# VEAX LLO Existing Cable Piers Locations

**NOTE:** This drawing is NOT correct yet. It was made by mirroring the VEAY drawing D1201231-v1. Its ultimate purpose is to show the existing cable tray and piers relative to the as-built IFO.

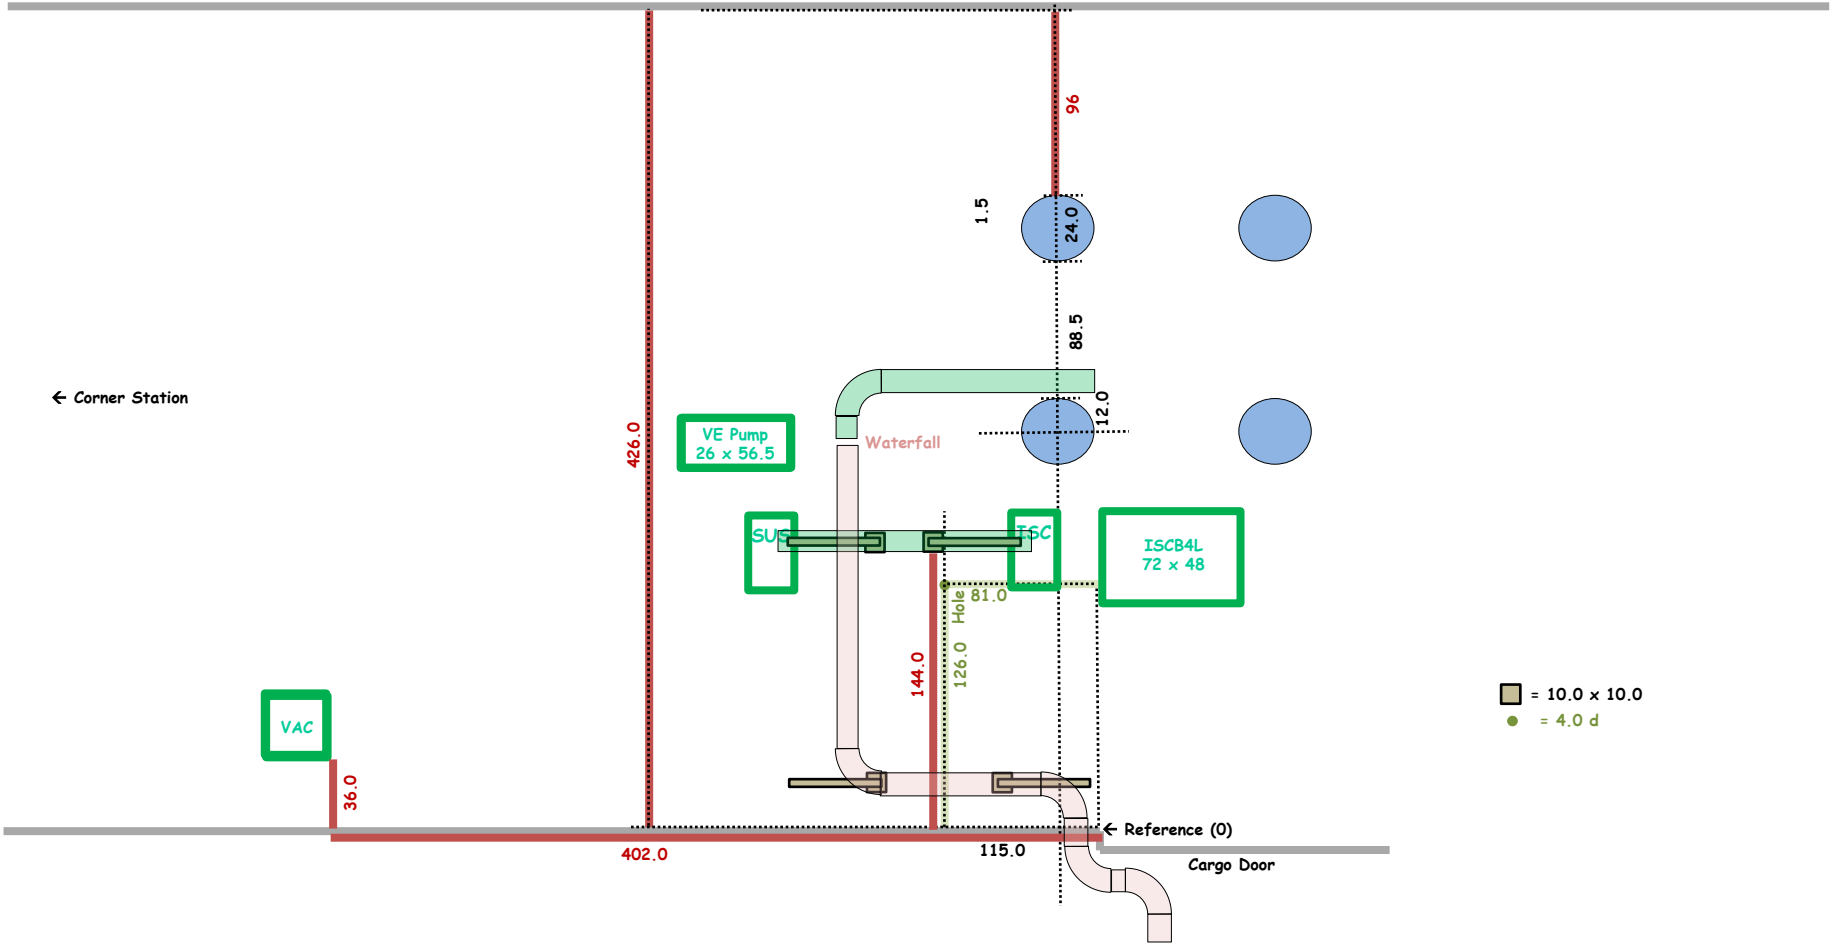
- 1) Where does 11U Short Rack (D1001423-v11) go? (Ignore)
- 2) Where does L1-AOS-XR1 (if it needs to exist) go? (Does not exist)
- 3) What does pentagon-2 mean regarding tray removal? Is there tray across the beam tube from L1-SUS-XR1? (Ignore)
- 4) Is the called-out 10' height important for some reason? LLO height is 8'. (OK)
- 5) What are the double doors in the note all about? (Ignore)
- 6) A door is missing from the garb room to the VEA. (Ignore)
- 7) The doors are missing from the mechanical room. (Ignore)
- 8) L1-VAC-XR1 is missing. (Shown)
- 9) All cabling that currently uses under-beam tray and the waterfall is missing. (Kurt)
- 10) The Photon Calibrator is missing. (Mounted to tube - part of OPLEV)
- 11) VE Pumps are not shown. (Shown)
- 12) Size of ISCB4L is not specified. (72 x 48)

- 1) Remove old cable tray and pier that interferes with dome parking.
- 2) Locate L1-ISC-XR1 farther away from existing pier for clearance.
- 3) Suggest joining basket around BSC to existing cable tray at waterfall.
- 4) Used removed pier to extend cable tray to L1-ISC-XR1.
- 5) Add cable tray to reach L1-SUS-YR1.
- 6) Remove parallel waterfall, move 'T' to primary waterfall.
